**Regarding: 06V-371**

# Technical BULLETIN

## 2004~2005 YZF-R1, 2004~2005 FZ6, 2002~2005 XV1700PC, and 2003~2005 FJR1300/A FACTORY MODIFICATION CAMPAIGN – Unstable Engine Idling

## IDENTIFICATION PROCEDURE

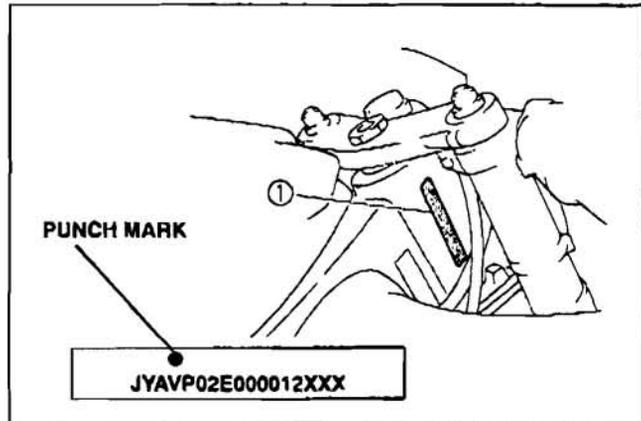
When the modification is complete, put a punch mark above the VIN (frame number) ① as shown.

Before modifying a unit, check for this punch mark.
